Response to Further Information

**Tandy's Lane Village Development Area
(Phase 2)**

SDCC Reg. Ref.: SDZ22A/0006

Figure 2.1: Extract Showing the Position and Layout of the 6 No. Traveller Accommodation Units

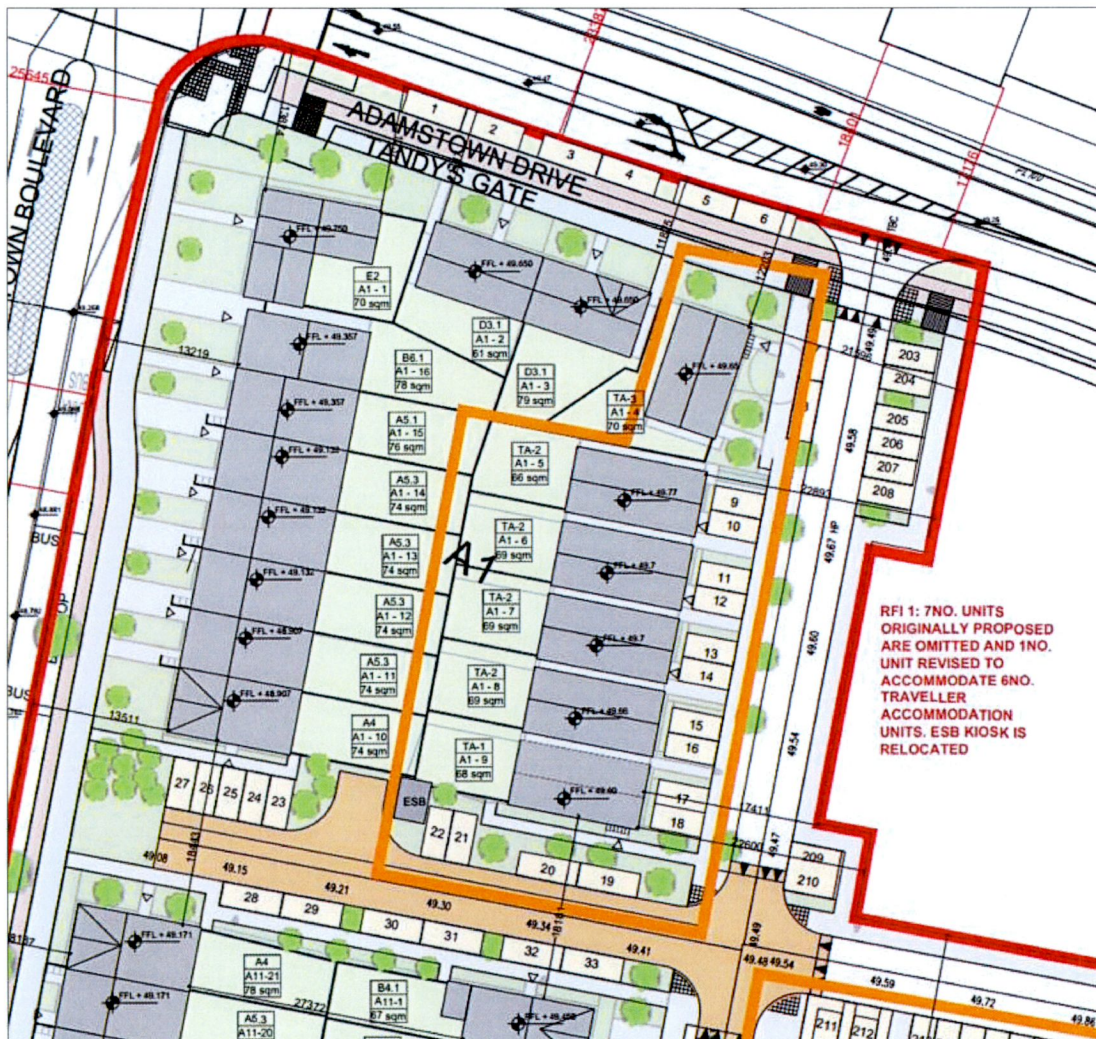
'Section 2.2(ii) Social Housing of the Planning Scheme states that social housing provision must include at least four traveller accommodation sites within the scheme lands. While Figure 2.4 does not indicate a Traveller Accommodation Site within the Tandy's Lane Village Development Area, under SDZ19A/0011 (Phase 1 of the Tandy's Lane Village Development Area) the planner's report stated that the traveller accommodation site in Somerton Development Area would be moved to the Tandy's Lane Village Development Area in order to be closer to the proposed primary school and local centre. This was indicated for the north western portion of the Development Area, within which the site of the subject application is located. The applicant is requested to liaise with the Housing Section in relation to typology and confirm how this would be addressed.'

The amended scheme now submitted in *Response to the RFI* includes the provision of 6 No. four bedroom traveller accommodation sites to the north-west of the site including associated parking for each unit. The design rationale for the traveller accommodation units is detailed in Section 1.1 of the '*Architectural RFI Planning Response*' document prepared by MOLA Architecture and enclosed with this *RFI* pack.

All of the units are detached with Dutch Billy style roofs and have been designed to ensure that they seamlessly integrate into the wider subject housing scheme. Consultation with the Housing Department in respect of the typology and layouts proposed took place on 30th June 2022 and the Housing Department confirmed their acceptability of the strategy. An extract from the Site Plan showing the position of the units is shown in Figure 2.1 below:

Figure 2.3: Extract from Section 3.2 of the 'Architectural RFI Planning Response'

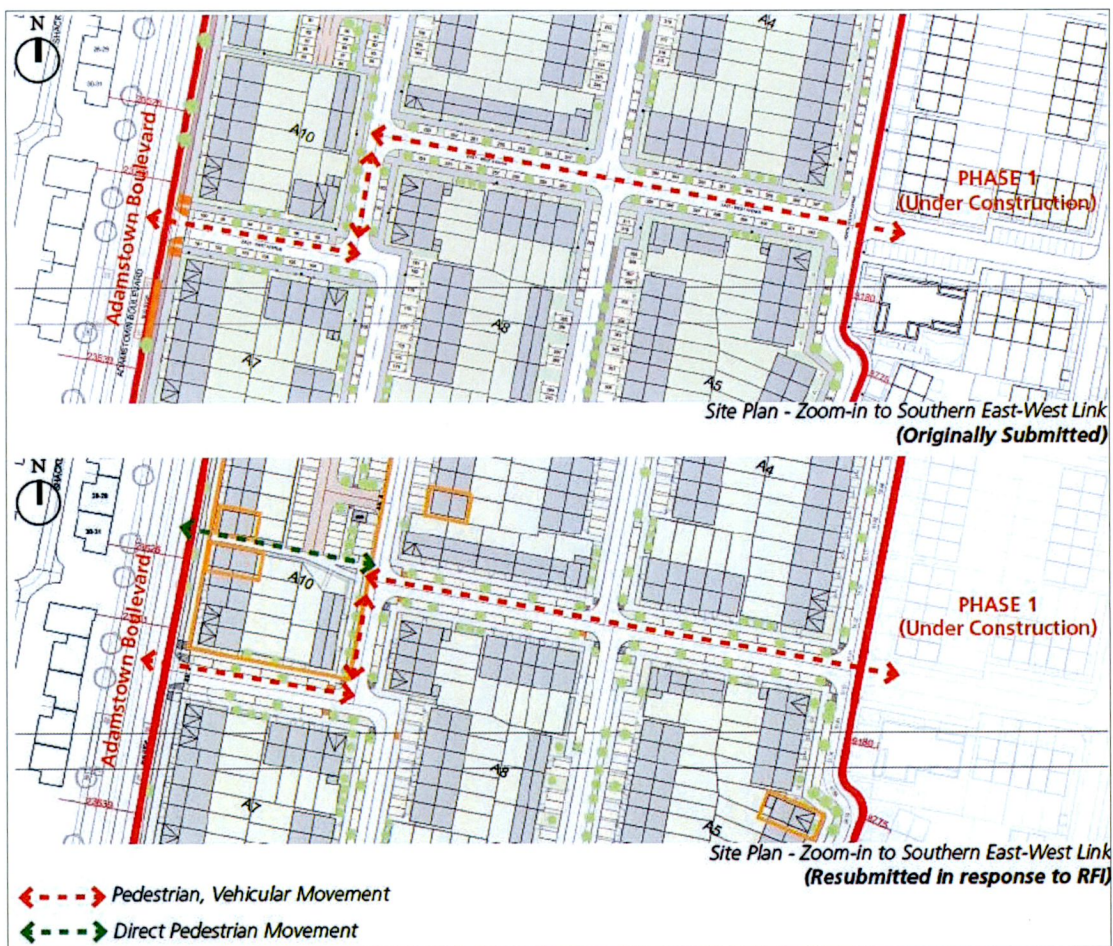
'The east-west links should be better provided for in the proposed development. While the northern east-west link is somewhat restricted by the permitted Phase 1, this should be facilitated in the subject site if provided for under Phase 3. The southern east-west link should be revised to provide better connectivity, in particular for pedestrians and cyclists.'

Nonetheless, the Applicant has now redesigned the northern east-west link road in the subject application and rearranged the housing layout in order to provide a straight road alignment from the future Village Centre (Phase 3) and Phase 1 under construction to the Boulevard to the west. As set out in Section 3.1 of the 'Architectural RFI Planning Response' prepared by MOLA Architecture, *'this has strengthened the east-west desire line and will give improved permeability from the Boulevard to the Village Centre and Phase 1'*. The northern public park has also been rearranged and enlarged as part of the proposed development and the redesigned and straightened road alignment will travel along the southern boundary of this modified park.

'Regarding the southern east-west link, we considered a straight road leading from Phase 1 to the Adamstown Boulevard, however we are restricted by the requirement to tie into existing service points along the Boulevard and the as-built access into Phase 1 in this location. To address this RFI, the housing layout along the Boulevard has been rearranged to provide a more direct connection from Phase 1 to the Boulevard via a pedestrian path. This allows a direct connection for those on foot and strengthens this desire line as highlighted in the SDZ Planning Scheme proposal'.

Figure 2.4: Extract from Section 3.4 of the 'Architectural RFI Planning Response'

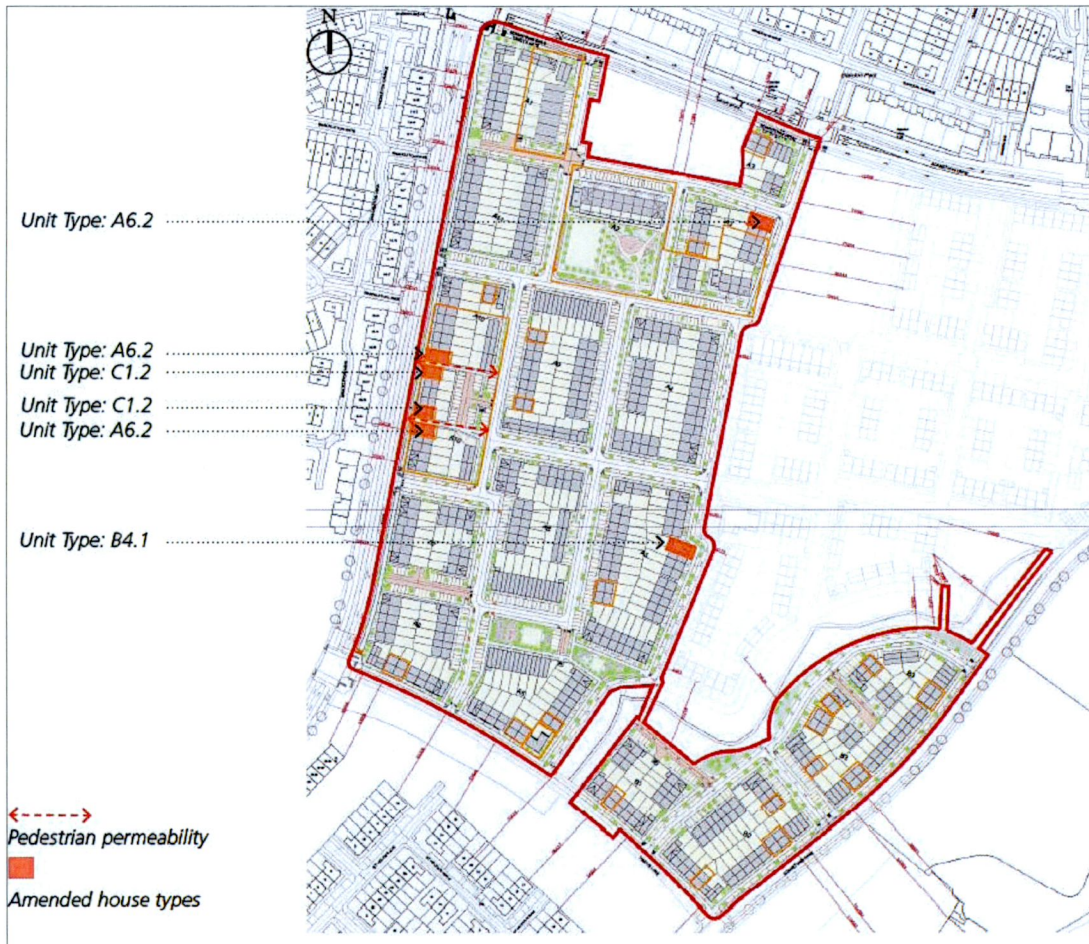
'It is not considered that sufficient passive surveillance of public footpaths where they run between the sides of houses is provided for. Further windows to habitable rooms on the side elevations (including at ground floor) of these house types should be provided.'

The Applicant has made amendments to relevant units to ensure that sufficient passive surveillance of footpaths is provided in accordance with Item No. 3 (b). As a result, MOLA Architecture have made amendments to units which are highlighted in orange in Section 3.4 of the 'Architectural RFI Planning Response' and extracted below.

A new C1 house type variant, C1.2, is proposed to better address the corner and public footpaths, as shown on the plan, with habitable rooms fronting onto the footpaths providing windows that overlook the public areas.

In addition, an existing front-entry unit (B6) at the east of the site has been replaced by a side-entry unit (B4.1), which improves the passive surveillance over the adjacent public road and footpaths in this location (unit type B4.1 highlighted on the plan).'

Figure 2.9: Drawing Showing the Location of the Future Phase 3 Development Sites¹⁰

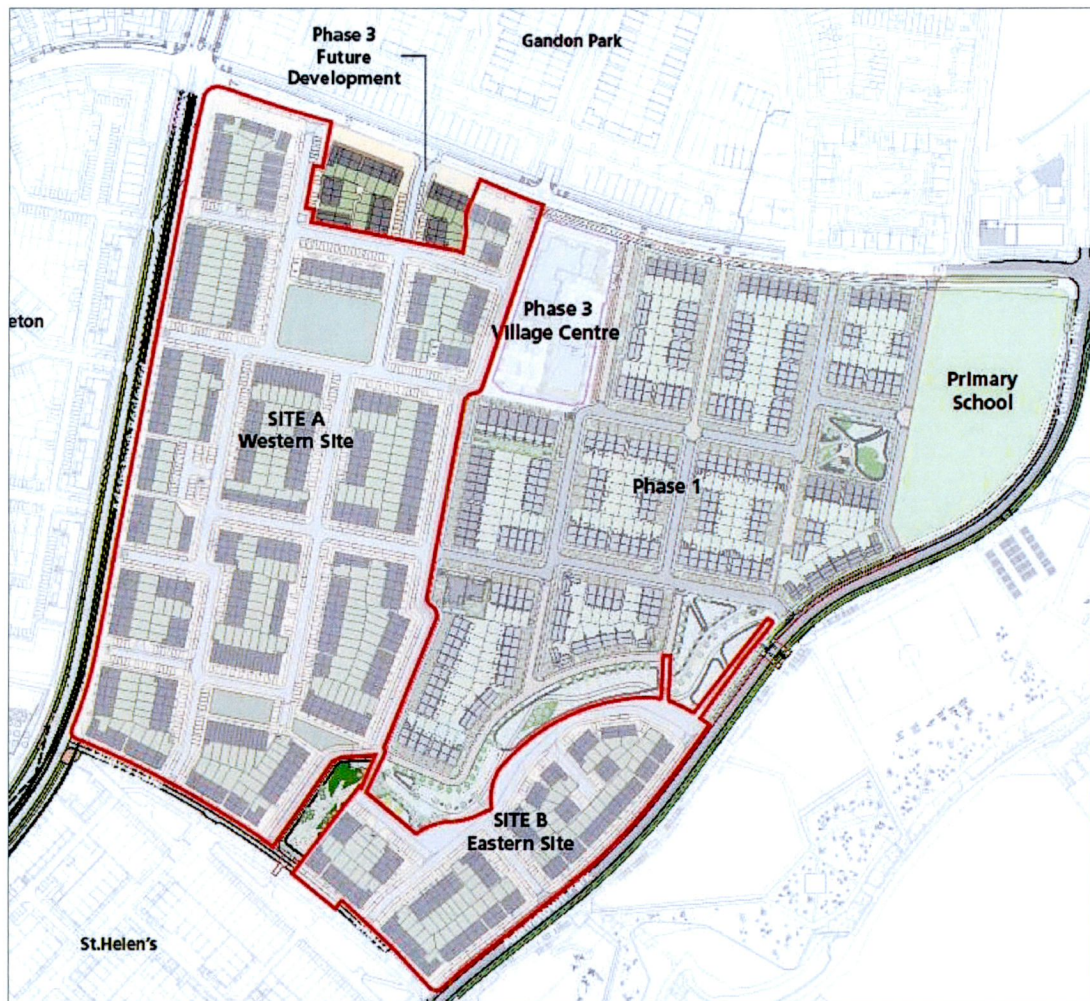
'While the subject application (Phase 2) would provide a residential density that meets the density requirements for the Tandy's Lane Village Development Area, in combination with Phase 1 it would be approx. 39 dwellings per ha. It would therefore have to avail of the 20% above or below the density range, that is subject to the applicant demonstrating that the required density for the overall development area can be met through future development proposals. Phase 3 is the remainder of the lands in the Tandy's Lane Village Development Area and would therefore have to provide for the required density for the overall development area. The applicant is requested to clarify if this can be achieved through Phase 3.'

As shown in the table above, some 245 No. dwellings have been permitted in Phase 1 and are constructed/under construction. The proposed Phase 2 development now provides 354 No. units as a result of changes made as part of this RFI Response. Therefore, Phase 1 and 2 comprises a total of 599 No. dwelling units, and thus, 81 No. dwelling units are required to be delivered on future Phase 3 lands.

MOLA Architecture, as part of a response to RFI Item No. 2 have confirmed that 63 No. units can be provided on the Village Centre lands. Furthermore, MOLA Architecture have confirmed that 23 No. units can be accommodated on the future Phase 3 lands to the north of the Phase 2 lands.

Therefore, a total of 685 No. units (41 No. units per hectare) can be accommodated in the entire Tandy's Lane Village Development which meets the density requirements for the Tandy's Lane Village Development Area (which requires the provision of 680-935 No. units). Please see the summary table below which breaks down the number of units to be accommodated per phase:

Figure 2.12: Alternative Design Considered with North-South Hedgerow Retained

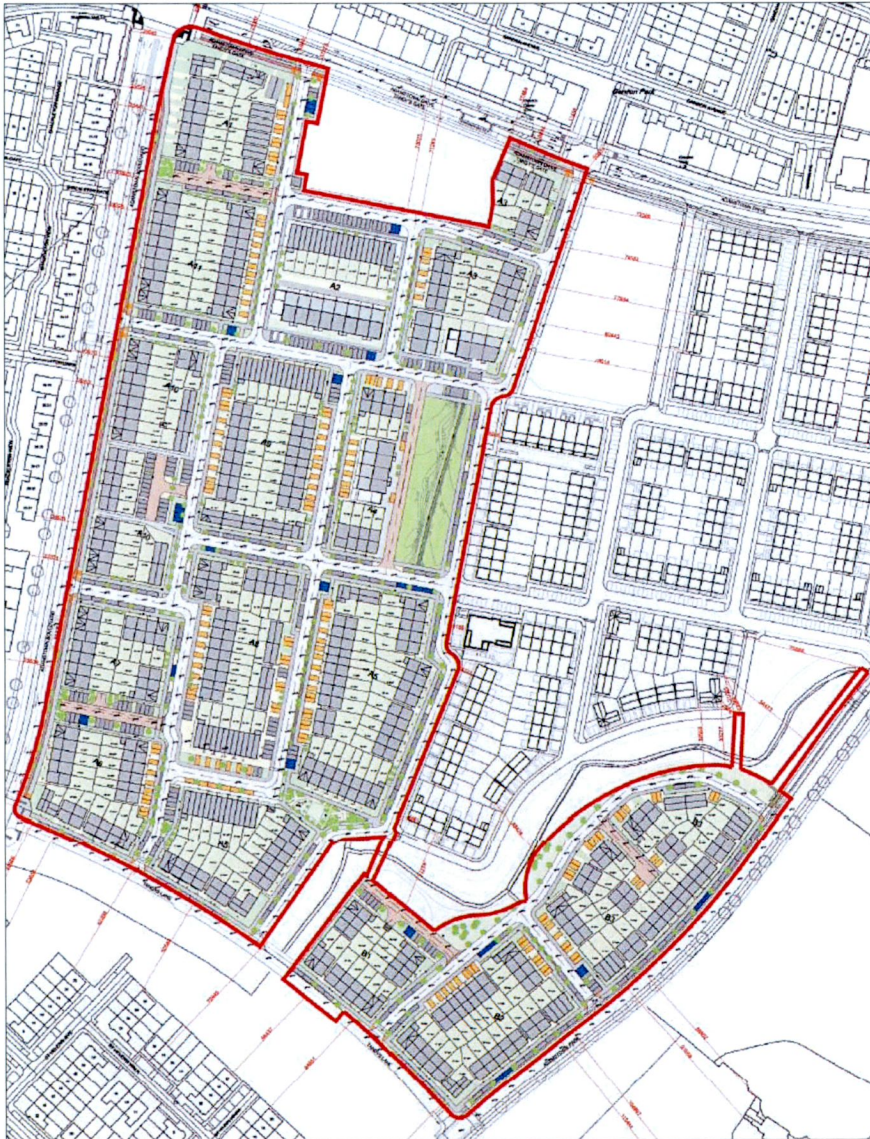
'The subject application proposes the removal of all the existing hedgerows on the site. It is not considered that the full consideration of the retention of these hedgerows, in particular the north-south hedgerow, has been clearly set out in the subject application. The applicant is requested to provide additional information in this respect. The applicant should also consider incorporating this hedgerow into the layout, in particular public open spaces, where possible.'

Furthermore, as part of the *RFI* response, the design team did explore the option of retaining the hedgerow, but it was concluded that this did not give rise to an appropriate layout, nor did it result in an enhanced biodiversity response on this site. In this regard, Brady Shipman Martin note:

'The project architects have drafted and considered an alternative design for the proposed development which provides for incorporation a partial section of this hedgerow as an unbroken length of c.85m within a new linear park. However, this option involves the loss of the southern park proposed in the planning application.'

Please see the alternative design that was considered below which retains the hedgerow and does not provide any quality and useable open space that would be provided if a partial section of the

hedgerow is retained. The design team consider that the scheme now presented in the RFI response lends to a more suitable design response that will create a superior living environment.
